ZONING, PLATTING & ADVISORY COMMITTEE (ZPAC) September 3, 2024 – Approved Meeting Minutes

Petition 24-24 James W. Filotto on Behalf of Oakland Avenue Storage, LLC

Re: Filotto Roofing – Site Plan

、JE T N . <u>1 41</u> I ATE: I AWN BY: ____T HE KEI BY: ____

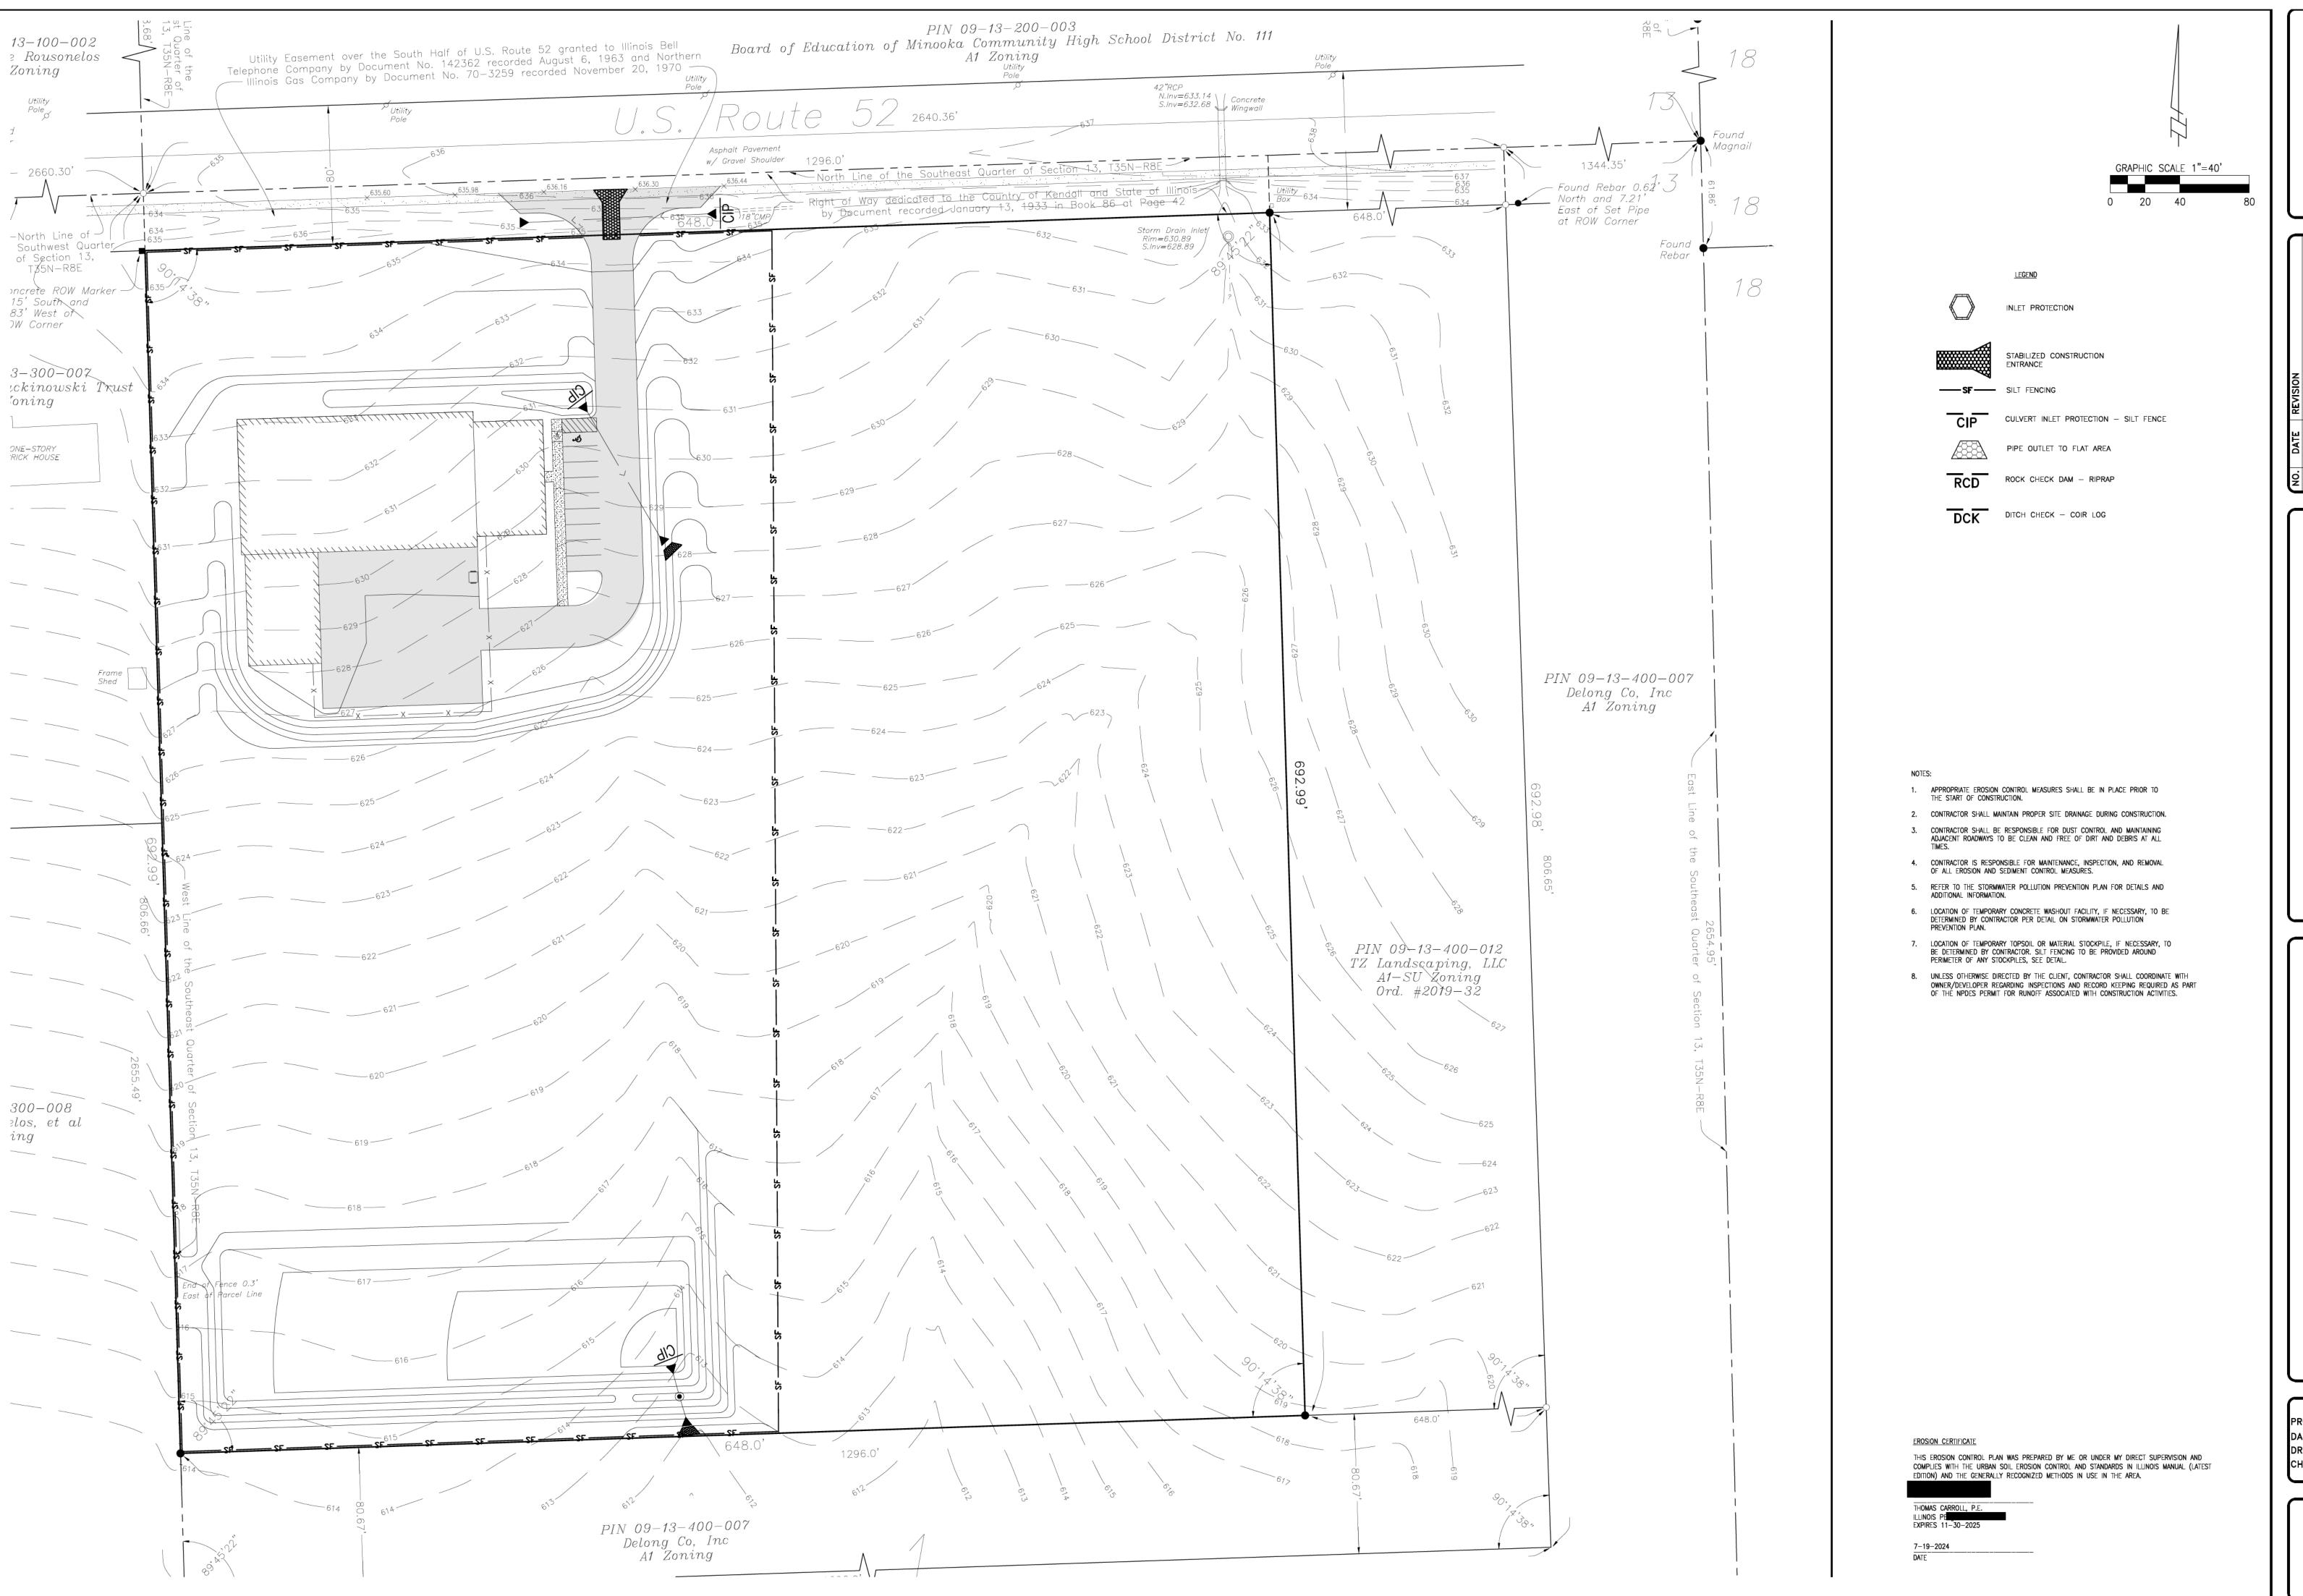
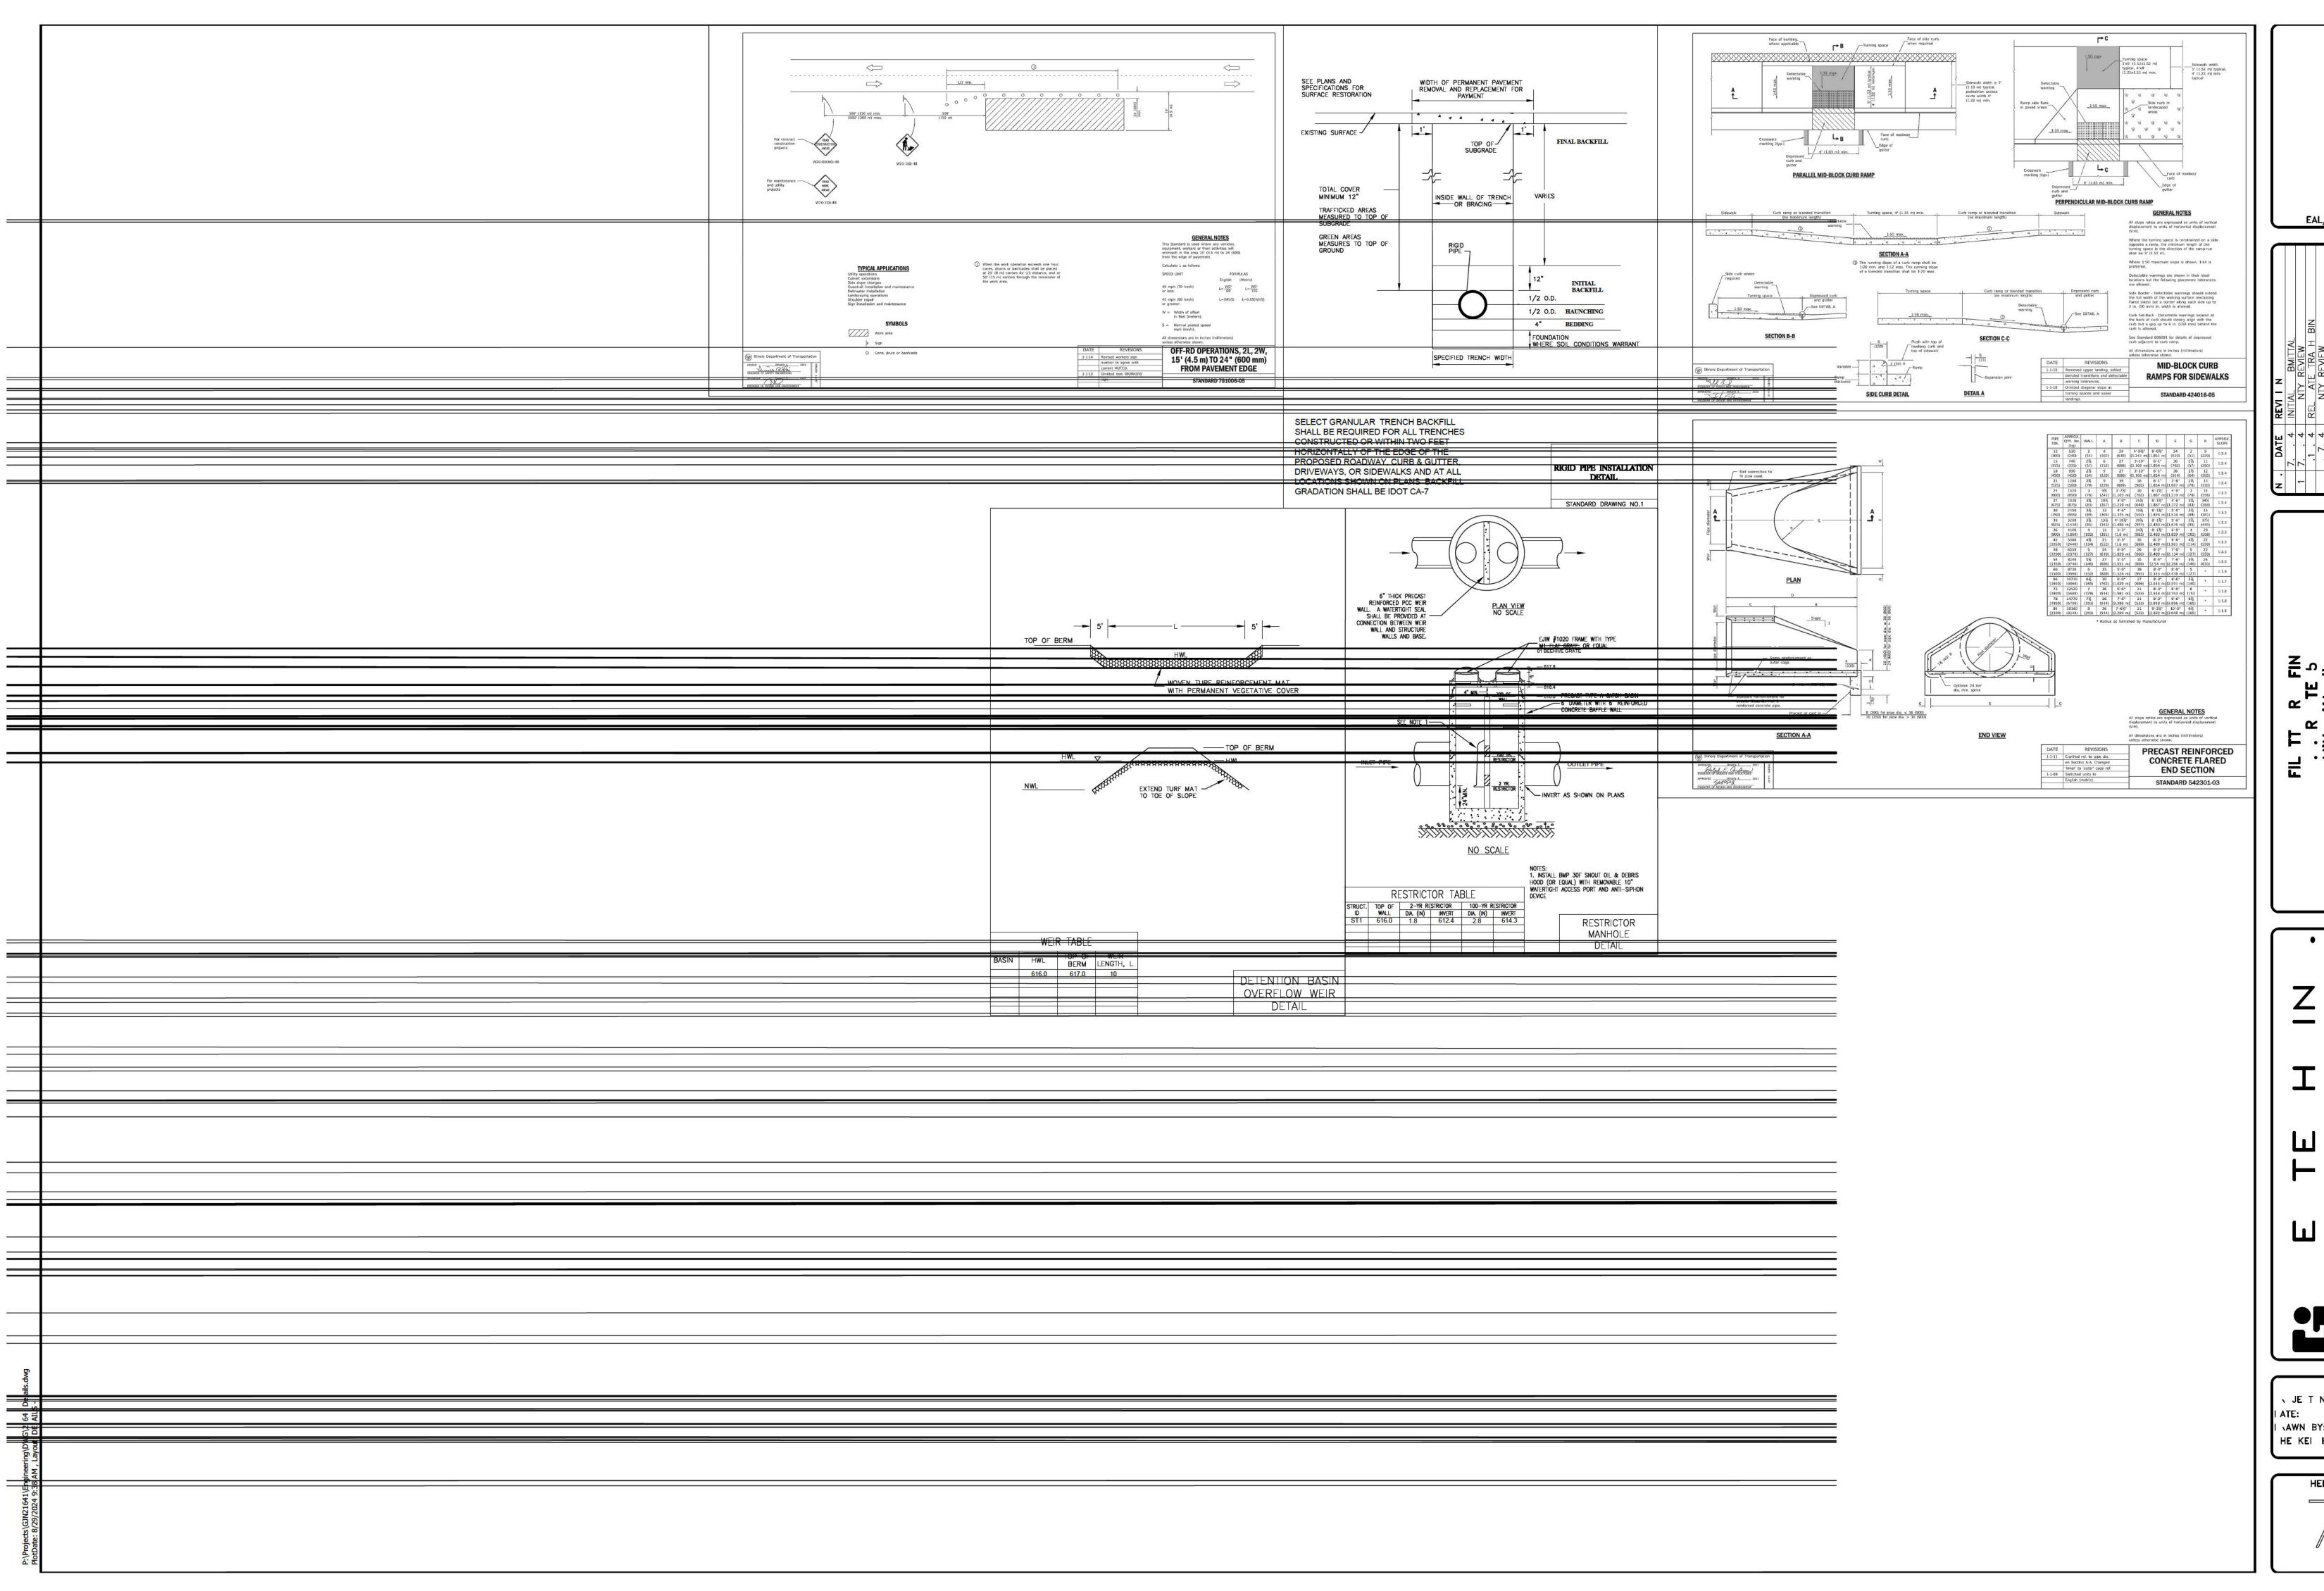
- 1. In the Stormwater Management Report, the Detention Tributary Area exhibit and detention calculations reflect the basin provides detention for the disturbed 2.87 acres, however, in proposed conditions the basin will accept runoff from an additional area between the proposed disturbance and possibly areas north of the proposed building. Please evaluate the overflow weir for this additional flow as to depth and velocity with the understanding overflow conditions will occur more frequently. The overflow weir calculations have been updated to include both the developed area and the undeveloped area that are both tributary to the proposed detention basin.

- 2. The weir coefficient is represented as two different values in the stormwater report. Verify the appropriate value. Also verify the weir length in the calculations matches the plans. **The stormwater calculations have been updated to reconcile the weir coefficients.**

- 3. Site Improvement Plans Please add dimensions to the restrictor manhole detail to verify the minimum 4" clearance will be met with the proposed top of wall elevation. Revise the grate type to maximize the overflow potential using a beehive type or "01" for EJIW products. The rim of the restrictor structure has been raised slightly to accommodate for the extra height of the beehive grate. Also, the restrictor structure detail has been updated to include dimensions to demonstrate that there will be adequate clearance for the top of the wall in the restrictor structure.

- 4. We understand the drainage swales along the east and west limits of the disturbed area are intended to capture flow from disturbed areas and route it to the stormwater basin. The definition of the swale is lacking in some areas. It is preferred that a typical minimum swale section be depicted that call out a minimum swale bottom side slope and depth to convey flows. Verify minimum depth with a channel capacity calculation. It is not necessary to revise all contours or include this additional area in the stormwater calculations, however we have no objection if that is done. Our primary concern is that the final field conditions will indicate clear capture and routing of the flows. Typical swale sections have been added to the Grading Plan. Also, Appendix 5 has been added to the Stormwater Report to demonstrate that the proposed swales have adequate capacity to convey the 100-year tributary flows to the detention basin.
